Subject: Mercedes Site Plan Modifications

Requested Change: Modification to Site Plan

Project Name: Mercedes-Benz of Coconut Creek
Project Location: 4250 N. State Road 7, Coconut Creek, FL 33073
Review/Application: Administrative Approval
Control/Permit No: PZ-10080005

SHEET TITLE:
SITE PLAN
 SHEET NUMBER:
C-2

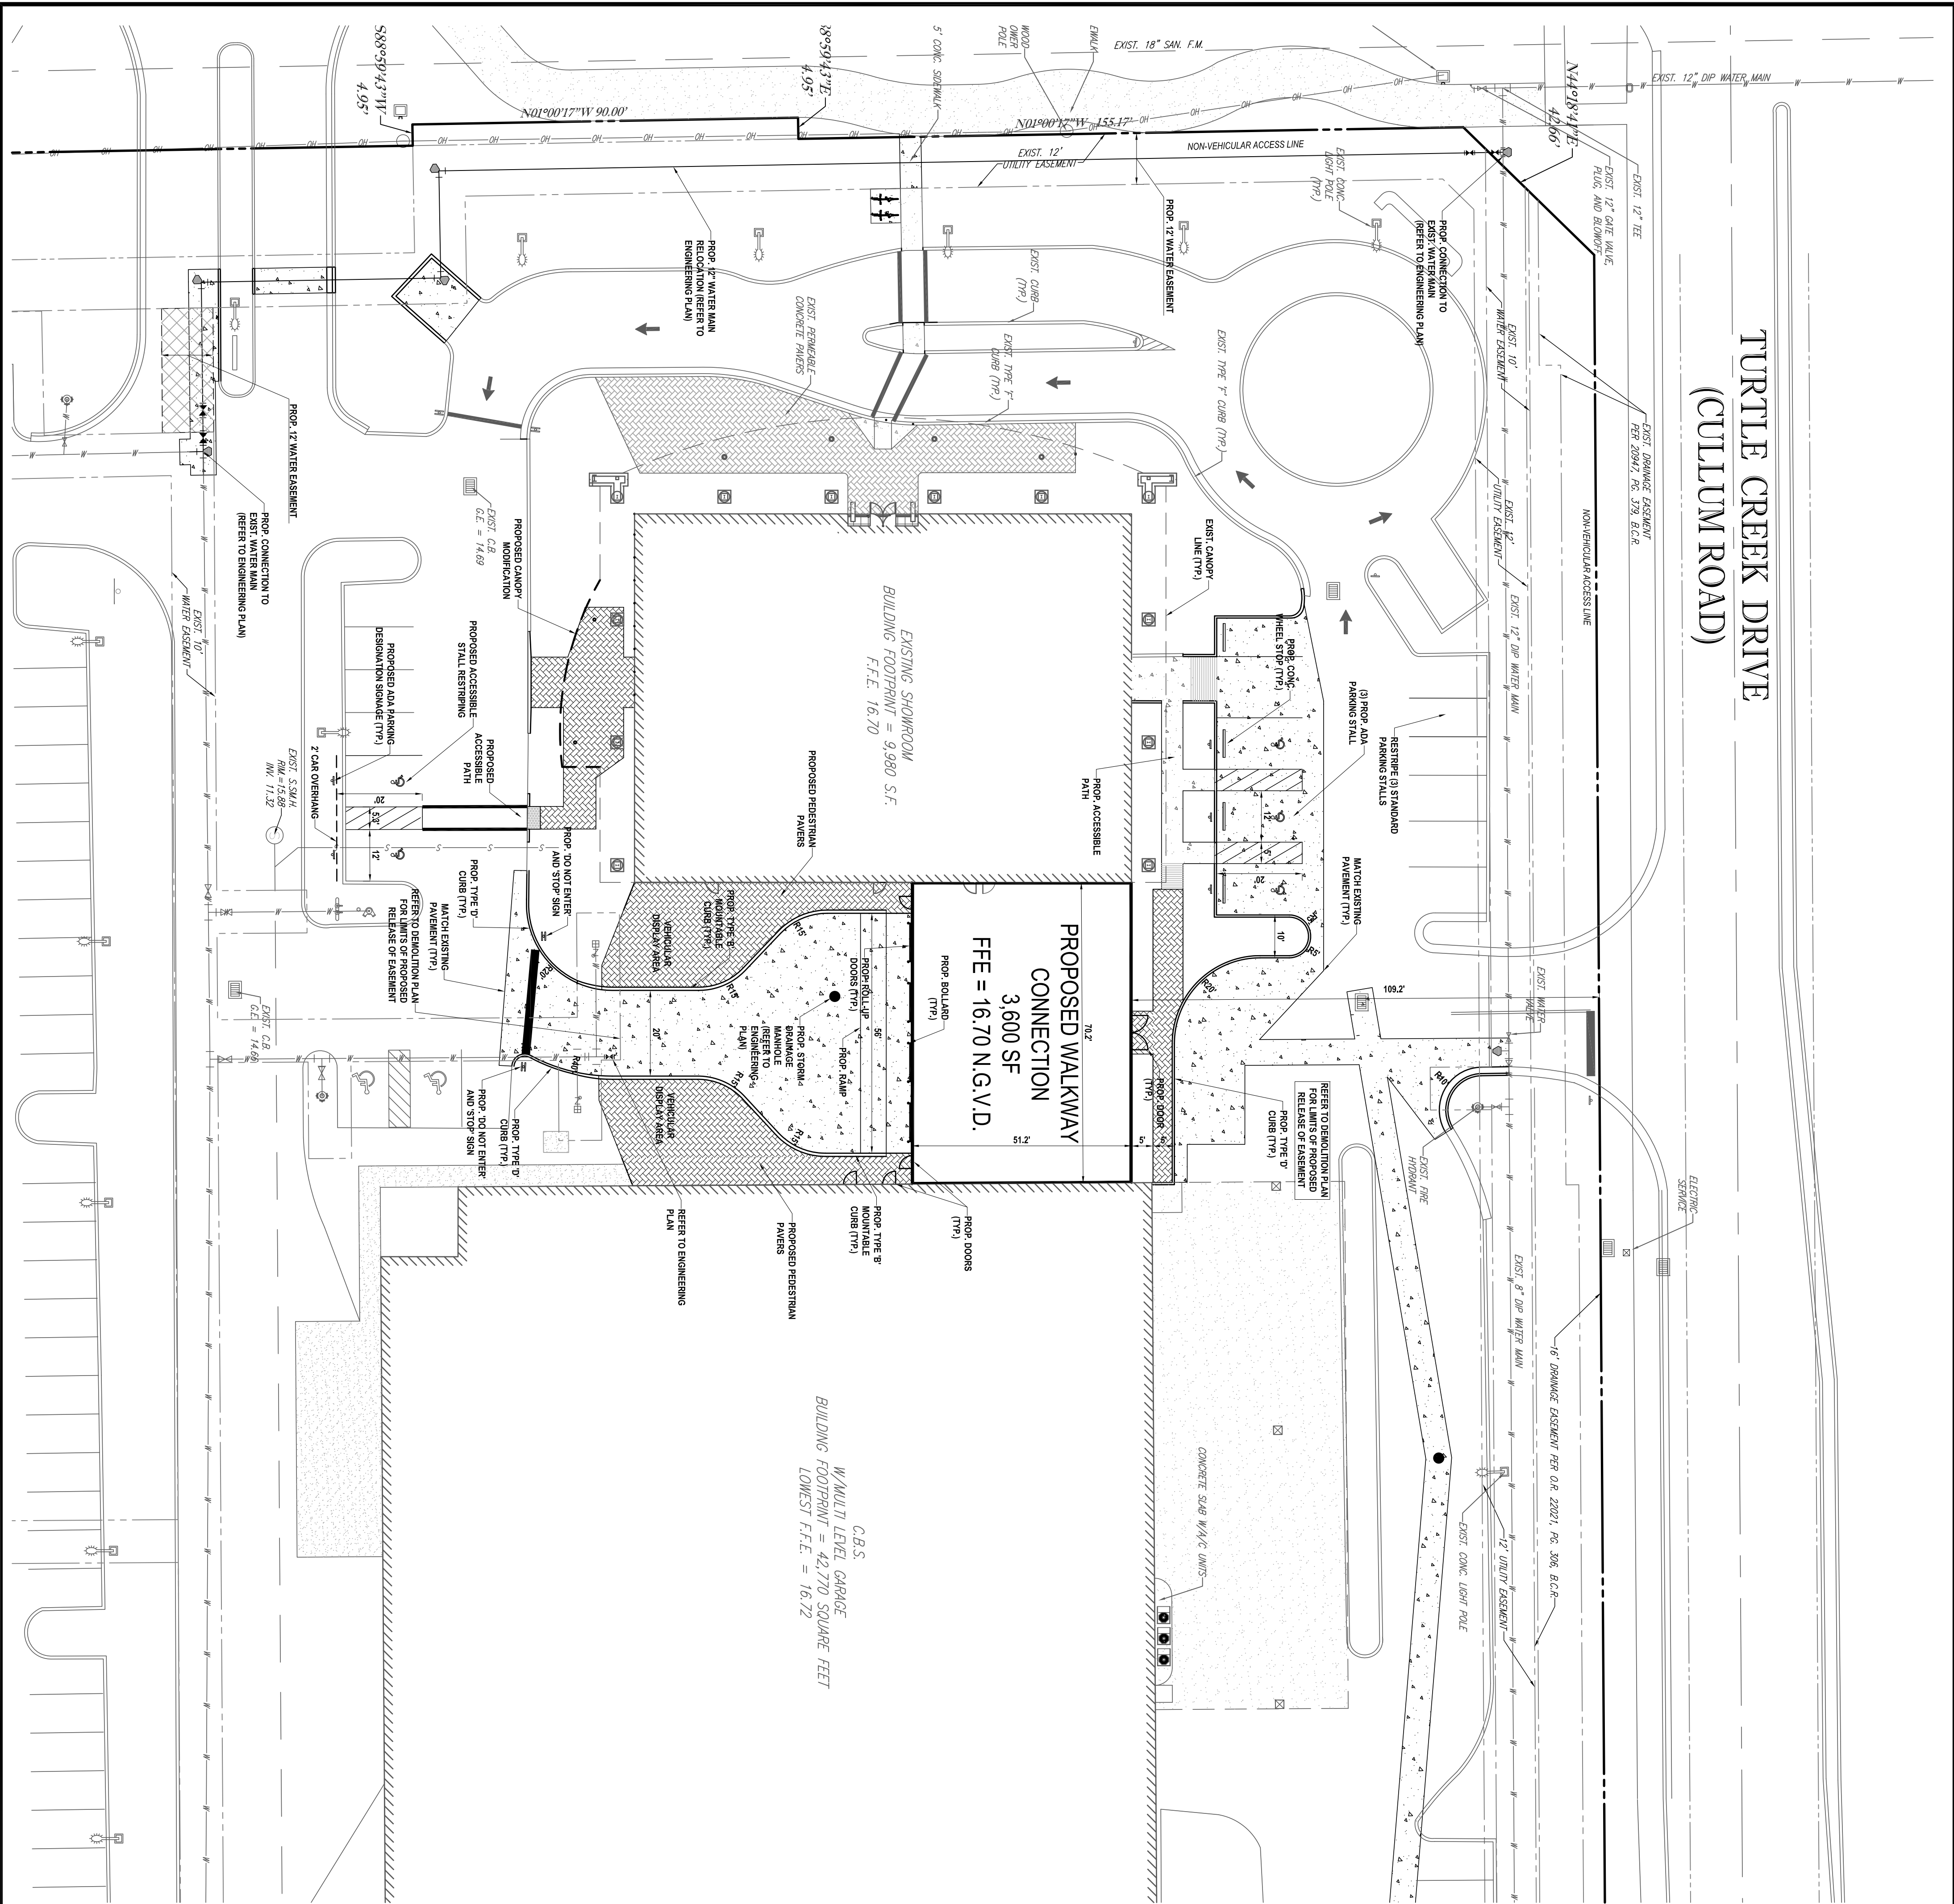
- Sidewalk directly north of building was shifted away from building
- Same sidewalk was changed from concrete to pavers
- Landscaping was shifted to accommodate the above
- Sidewalk on the south side of the building was changed from concrete to pavers
- Doorway on north elevation was shifted to be centrally located on building facade

1. The sidewalk directly north of the "proposed walkway connection" was changed from concrete to pavers. Also, the sidewalk was shifted away from the building to allow the proposed planters to engage the building elevation at this corner.
2. The hardscape south of the "proposed walkway connection" and within an interior alcove of the site has been modified to better define the pedestrian area from the vehicular area. Specifically, the pedestrian areas are installed as pavers while the vehicular area is concrete consistent to the building face where vehicle displays will occur within the structure.
3. The sidewalk immediately south of the existing showroom has been revised to pavers from concrete.
4. The doorway location on the north elevation of the "proposed walkway connection" has been centrally located as a single entry point where two doors were originally proposed.
